RE: DRAINAGE PLAN FOR 13812 WINTERWOOD WAY (L-23/D2A)

RE: DRAINAGE PLAN FOR 13812 WINTERWOOD WAY, SE

DRAINAGE REPORT

13812 WINTERWOOD WAY

EXHIBIT "E"

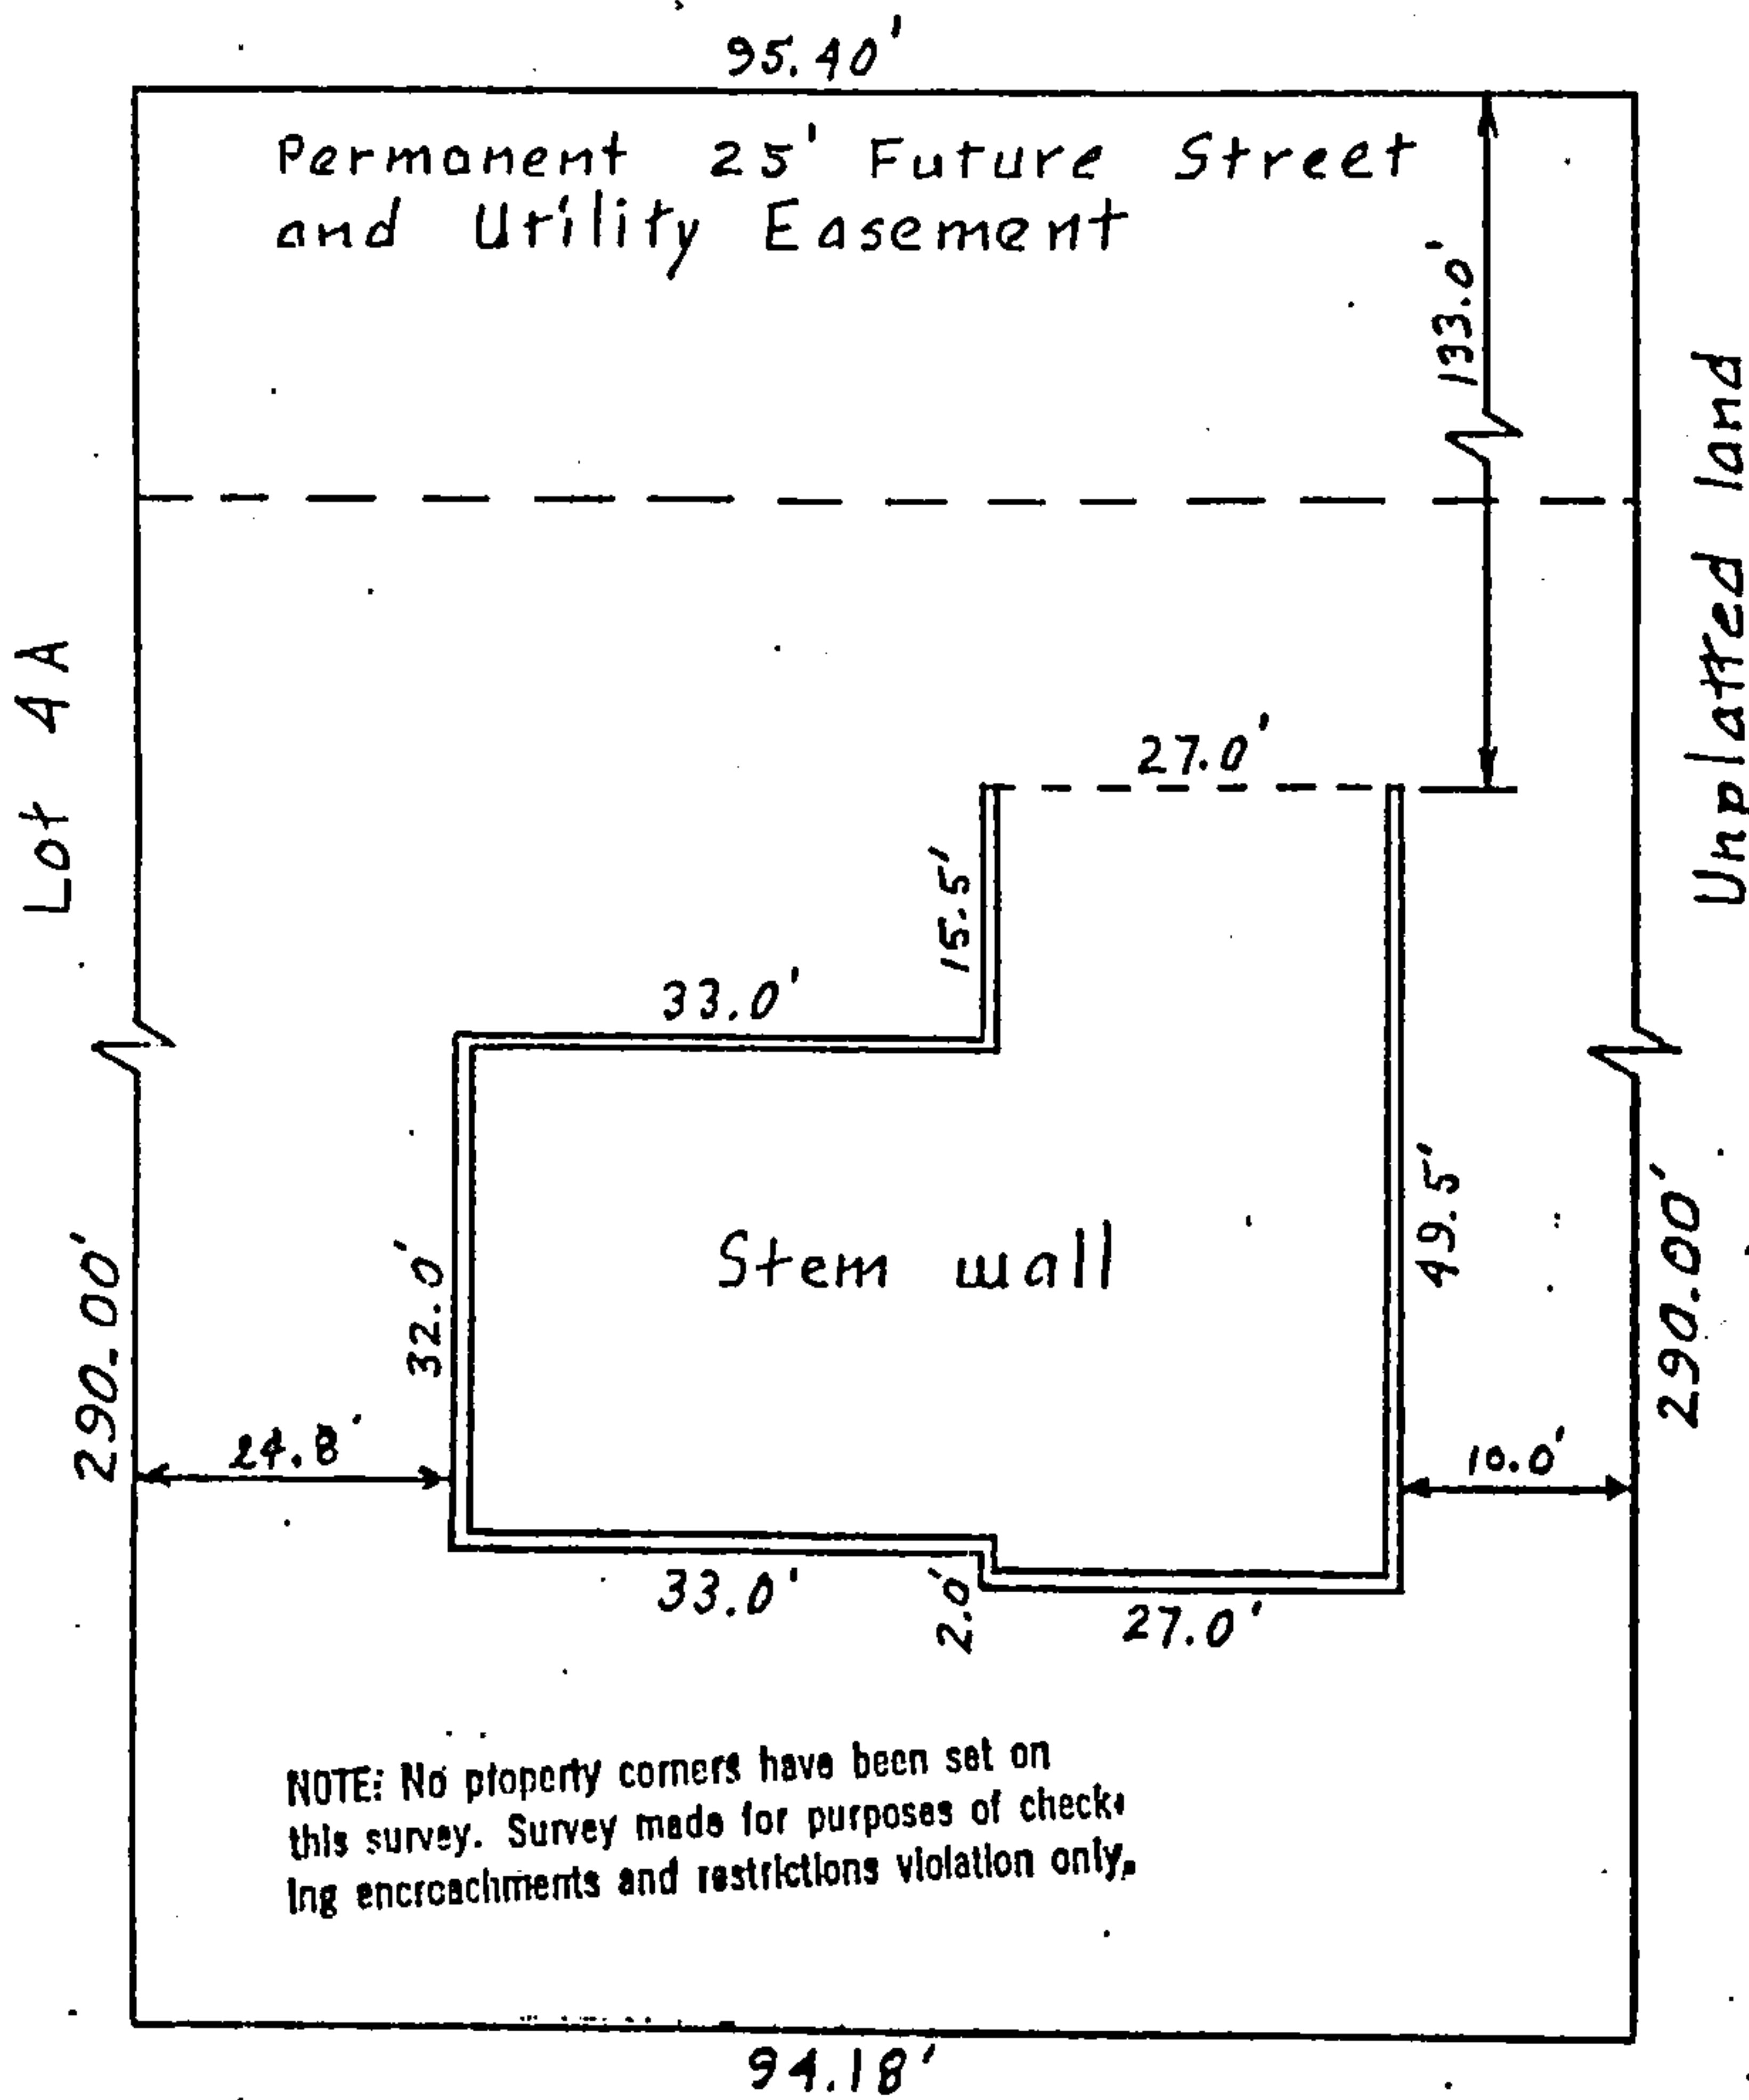
A field visit to the referenced site has been conducted, and it has been determined that the concrete channel was not constructed as shown on your engineer's design. A copy of this design (Exhibit "E") is attached for you to follow in the reconstruction of the channel.

Upon completion of the reconstruction, please call Richard L. Duran at 764-1699 for a final inspection.

EXHIBIT "F"

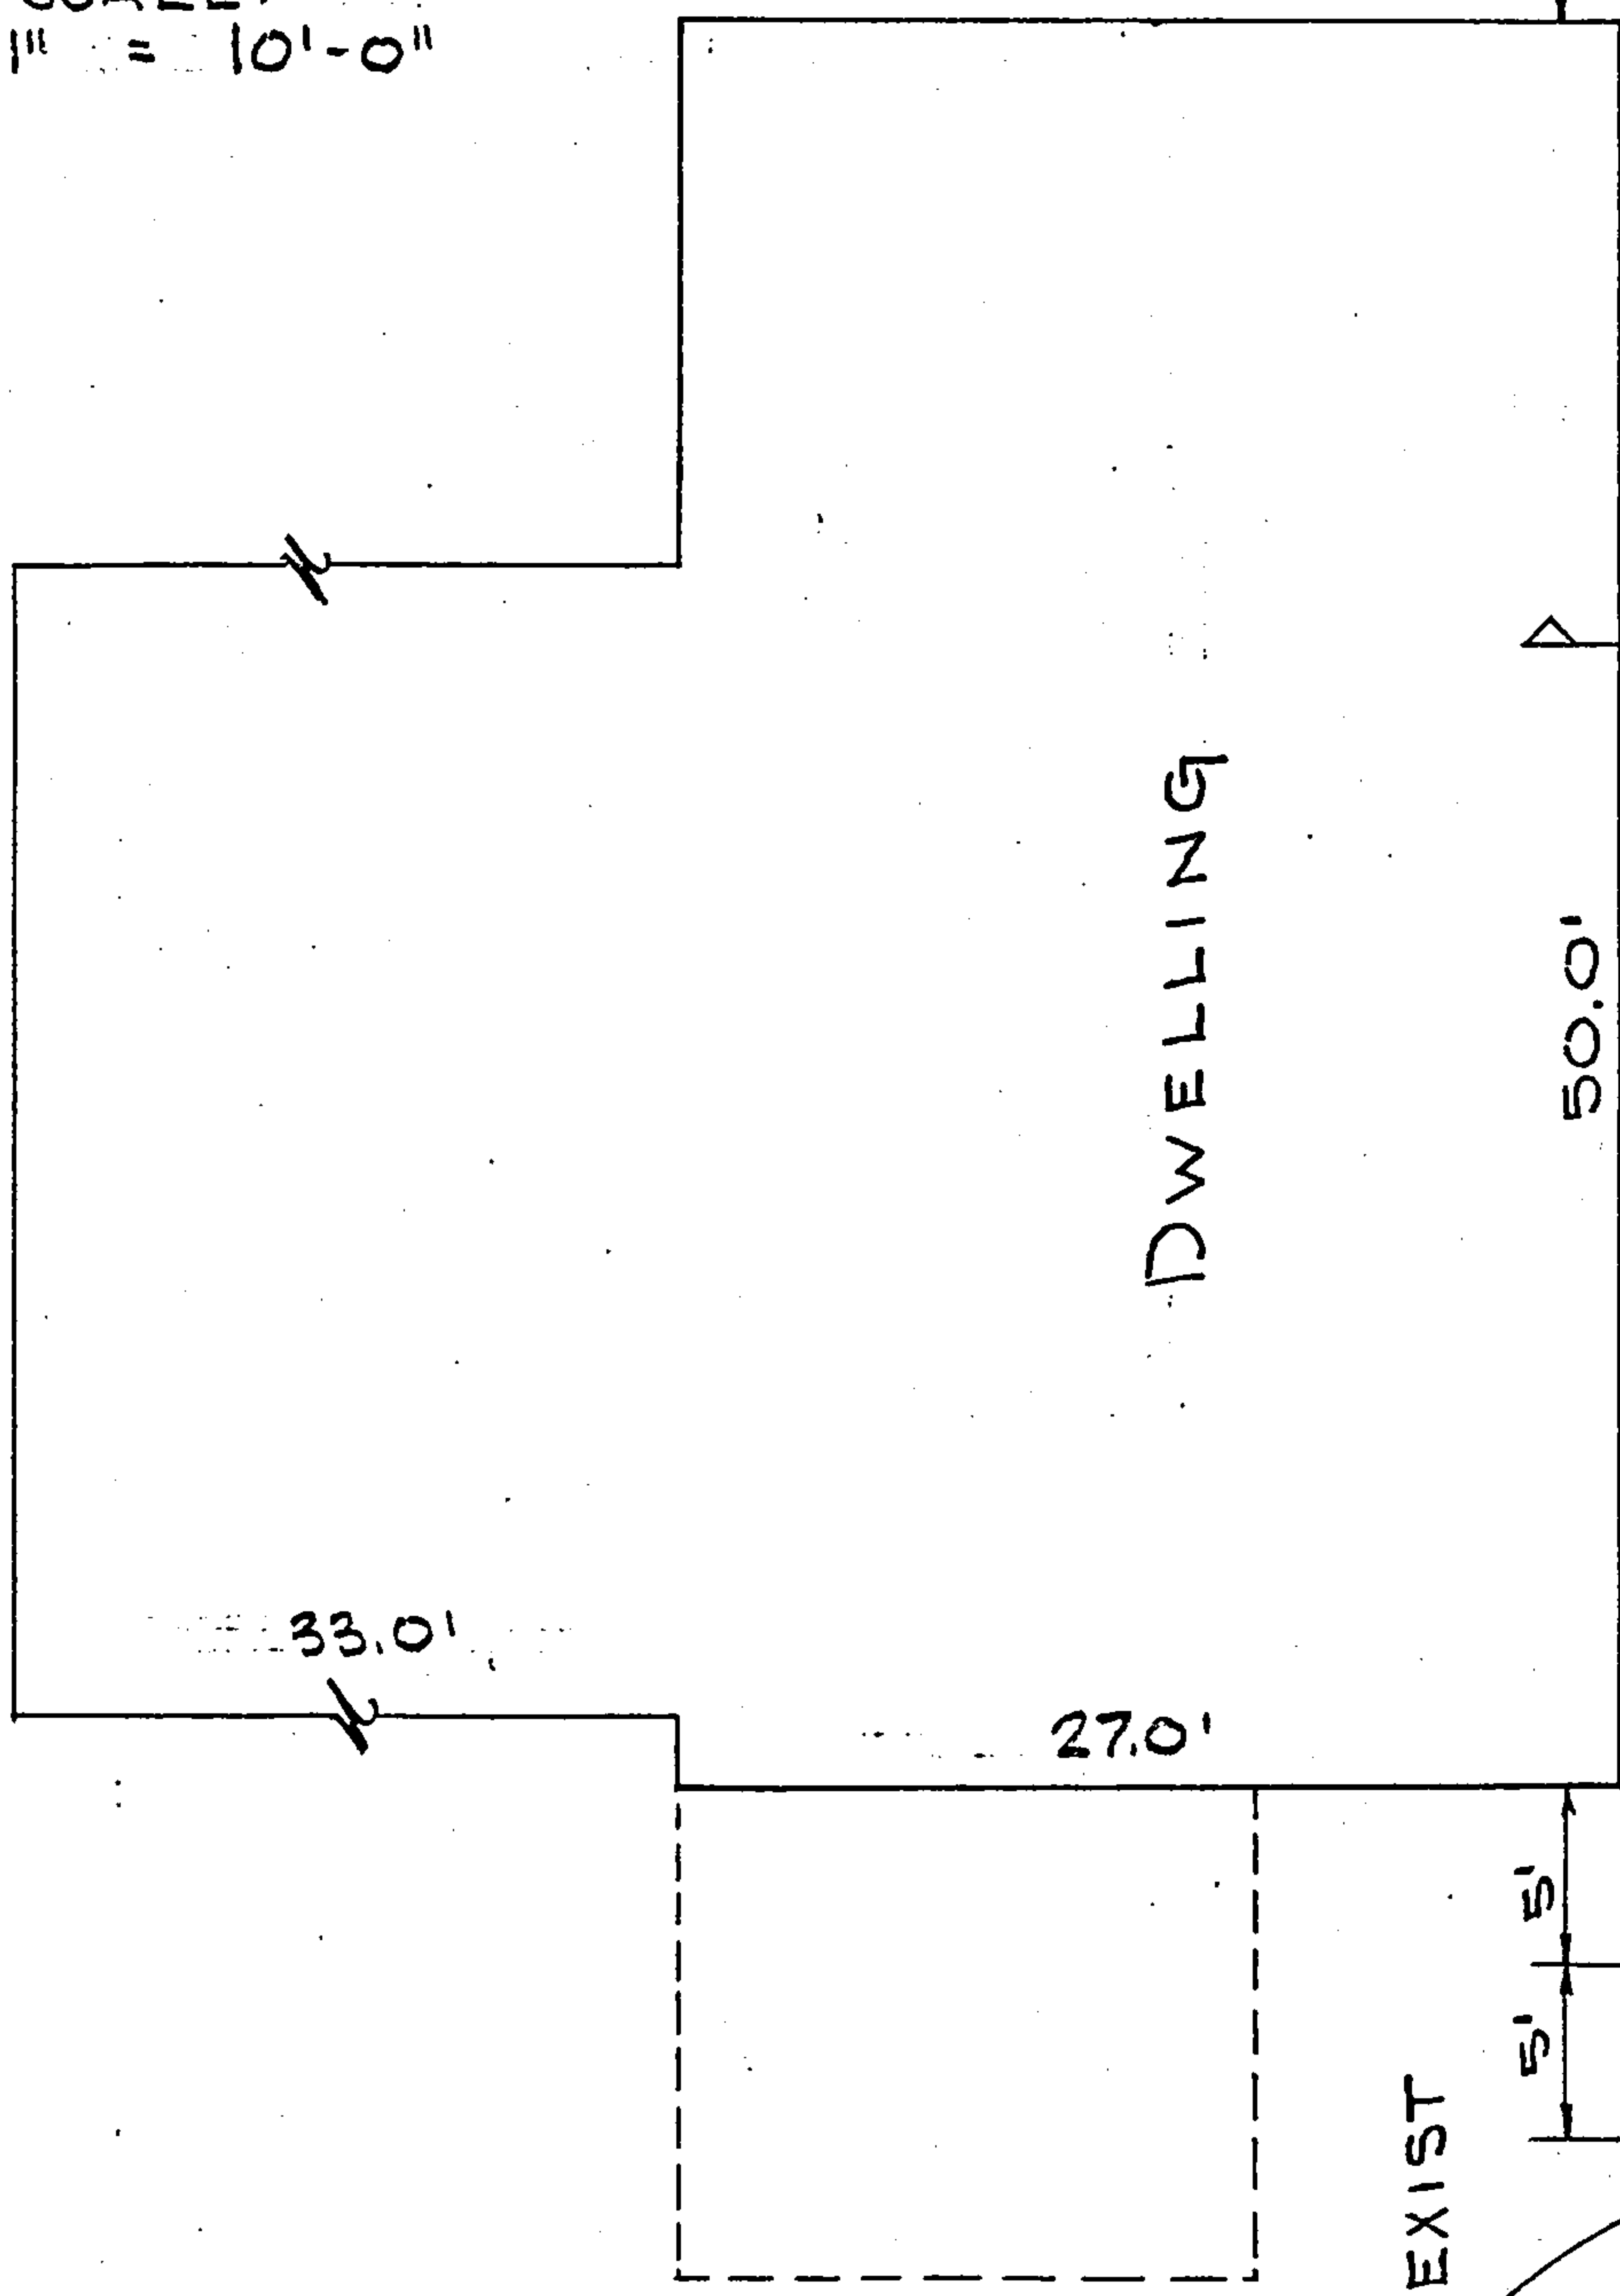
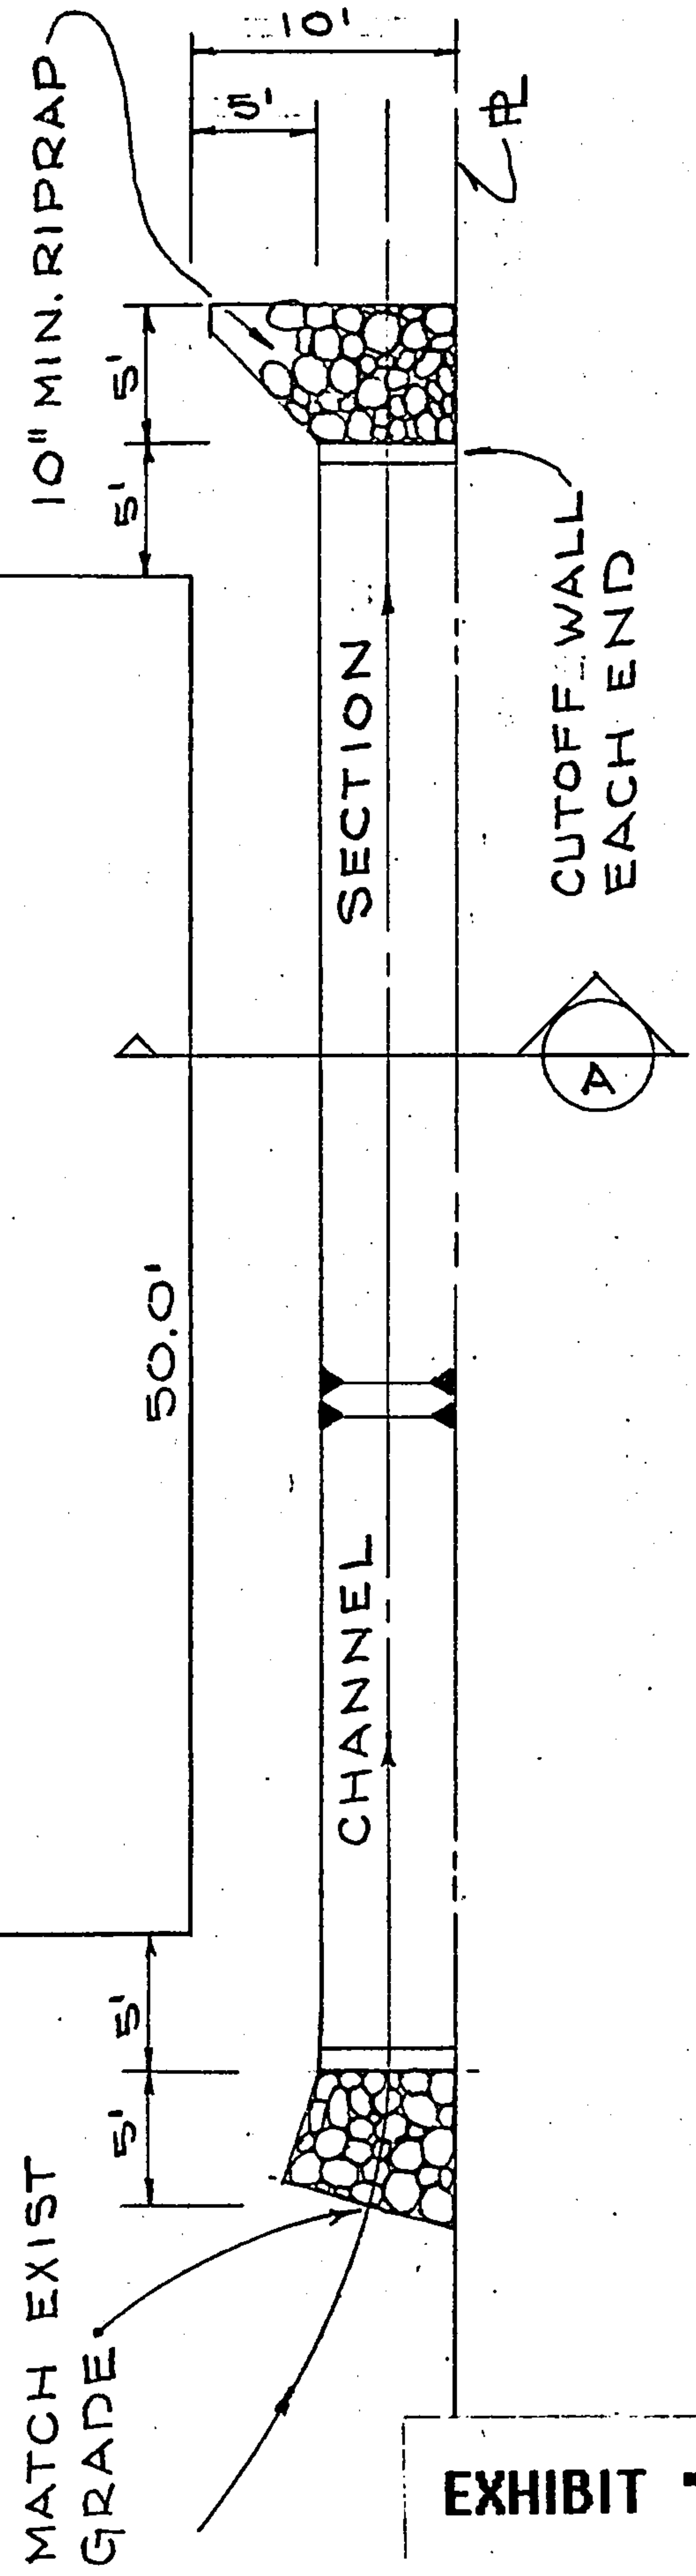
The above referenced plan dated January 7, 1987 is approved. Rick Duran, our drainage inspector, will need to be notified so that he can inspect the channel prior to final Certificate of Occupancy release. He can be called at 764-1699. The channel grades at the property line need to be as close as possible to adjoining lot grades.
